Chief Executive's Report

PT8TT16

Part VIII Development

Extension to an existing residential property and upgrade of on site
waste water treatment system, at,

Figure 3 Zone of Archaeological Potential (ZAP) over the site

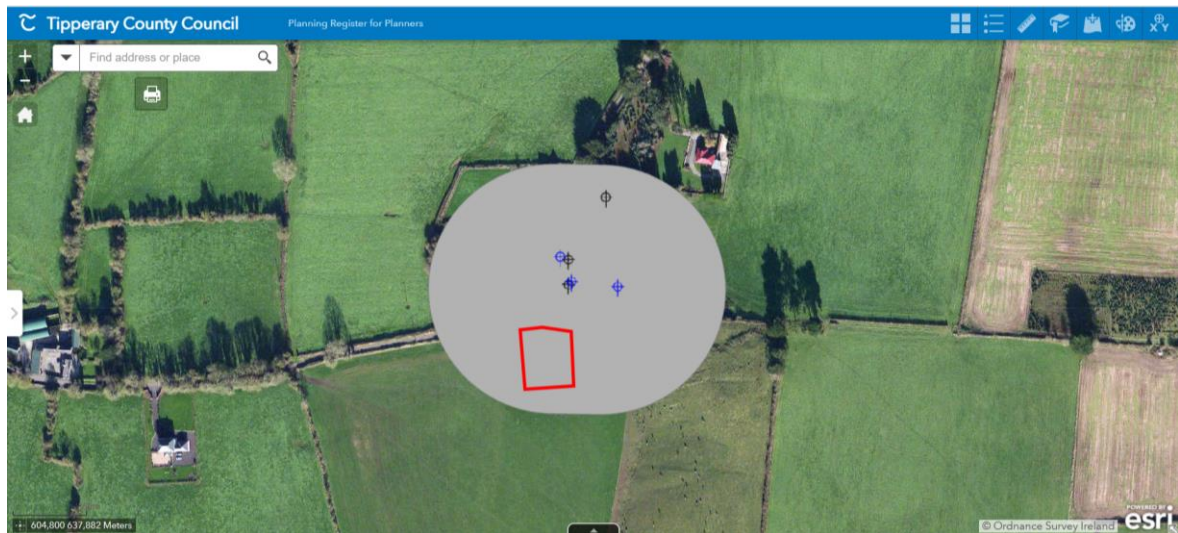
The application site is located within the Zone of Archaeological potential for 3 no. Recorded Moments hereunder;

- TS060-111002- Moated Site
- TS060-111001- Enclosure
- TS060-111003- Structure

The Part VIII application includes an Archaeological Impact Assessment (AIA) undertaken by AEGIS Archaeology Ltd. The report determines that without mitigation measures being implemented the groundworks associated with the development will possibly have a negative impact on potential subsurface archaeological remains. Section 6 of the AIA recommends mitigation measures in the form of archaeological monitoring at construction stage under licence from the National Monuments Service (NMS).

The submission received from the Department of Housing, Local Government and Heritage recommends that Archaeological Monitoring be carried out as a condition of Part 8 planning permission and a condition be will attached as recommended.

- a) The applicant is required to employ a suitably qualified archaeologist, licenced under the National Monuments Acts 1930–2014, to monitor all groundworks required for this proposal. Please allow **5-6 weeks** to facilitate the processing of an Archaeological Licence. No groundworks are to take place in the absence of the archaeologist.

- b) Monitoring of groundworks is to take place to the uppermost archaeological horizons only, where they survive. Should features/deposits of an archaeological nature be discovered during the course of monitoring, groundworks shall stop pending further advice from the Department of Housing, Local Government and Heritage (DoHLGH). Please note that all features/archaeological surfaces are to be hand-cleaned and clearly visible for photographic purposes. Section excavation through features to establish their nature and/or extent shall only take place where an archaeological licence is in place and this is agreed in advance with the Licensing Section of the DoHLGH.

- c) The features shall be planned and photographed and an interim report submitted to the DoHLGH pending a decision as to how best to deal with the archaeology. The interim report shall also include an archaeological mitigation strategy outlining the preservation in situ and/or archaeological excavation of the features/deposits revealed. The applicant shall note that full archaeological excavation according to best practice will be required, including an excavation reporting and post-excavation analysis, where preservation in situ cannot be achieved.

- d) The applicant/developer shall be prepared to be advised by the DoHLGH with regard to any necessary mitigating action as outlined above. The applicant/developer shall facilitate the archaeologist in fulfilling all aspects of this condition.

- e) On completion of the archaeological monitoring, a report shall be submitted to both the Local Authority and the DoHLGH, including the results of any post-excavation analyses, in to order to comply with this planning condition and the requirement of the archaeological licence.
